ADDENDUM No. 4 – June 19th 2025

PROJECT: PEDESTRIAN PLAZA
BID # CB-2543
Abilene, Texas

CYPRESS STREET PEDESTRIAN PARK
ABILENE, TEXAS

C1.0

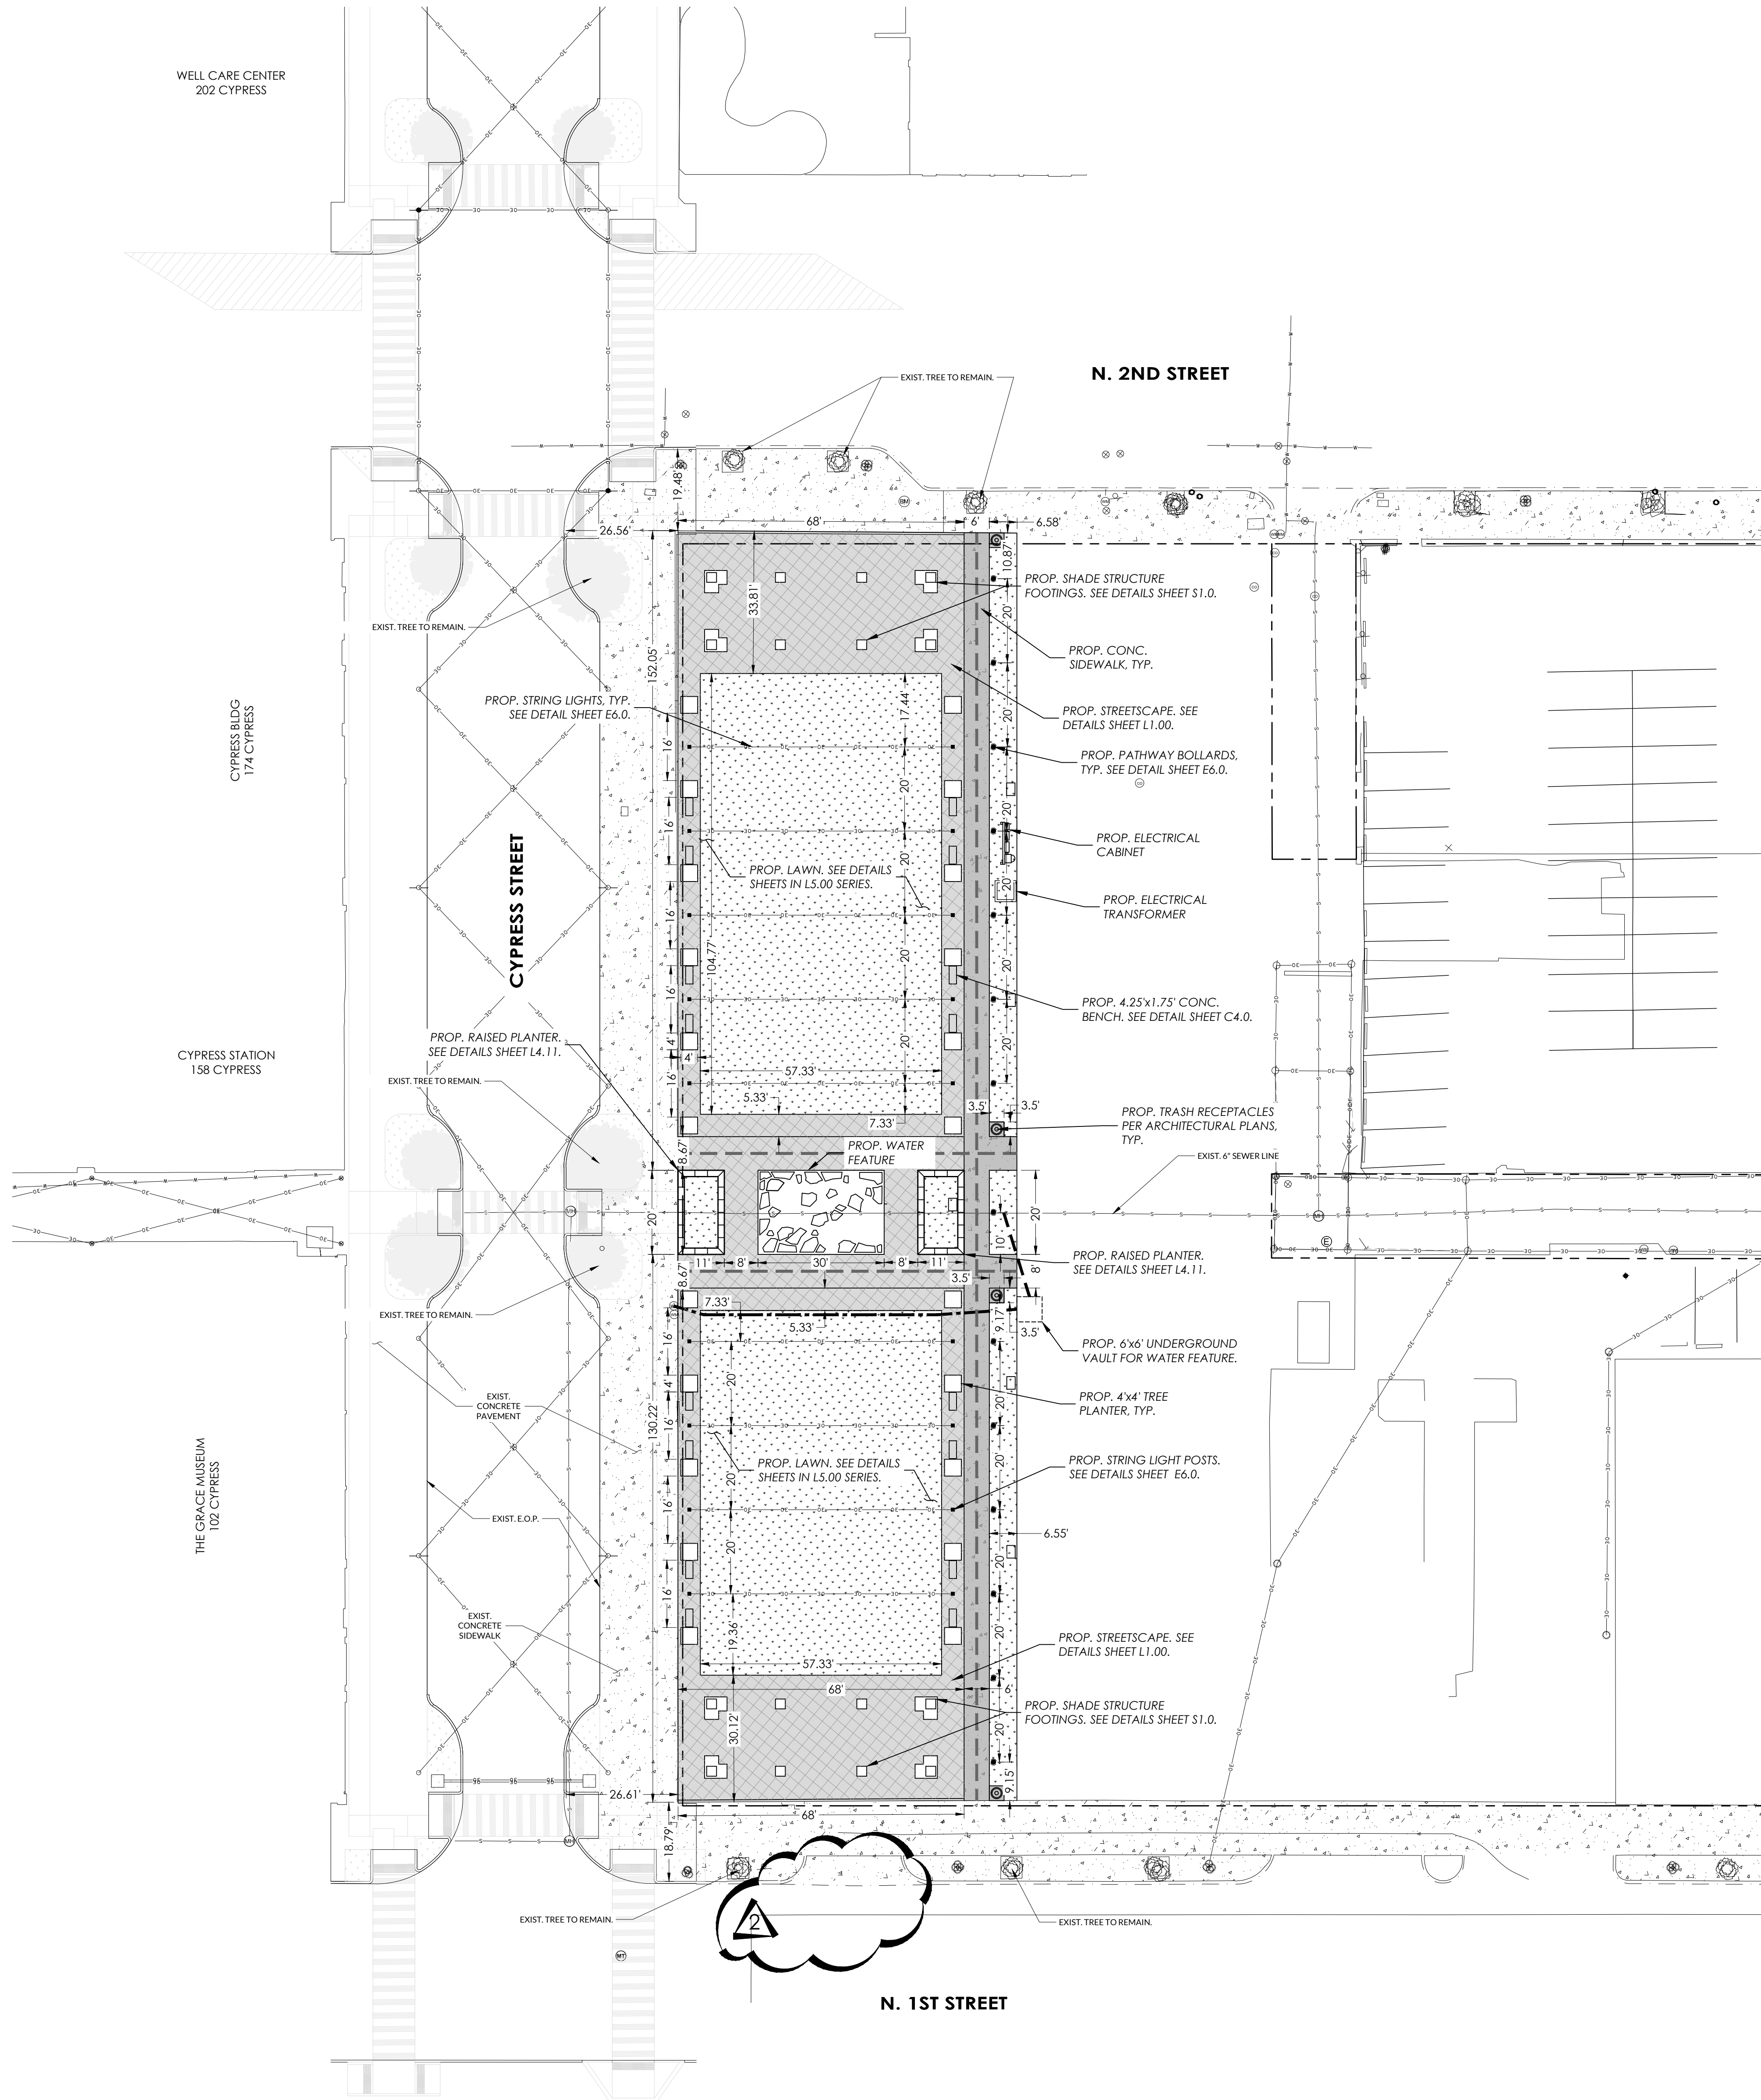
1. Revised Sheet C1.0 – Remove replacement of drive approach from project.
2. Revised Sheet C2.0 – Remove replacement of drive approach from project.
3. Revised Sheet C3.0 – Remove replacement of drive approach from project, Remove and abandon existing water meter.
4. Revised Sheet L0.10 – Remove replacement of drive approach from project.
5. Revised Sheet L1.00 – Remove replacement of drive approach from project.
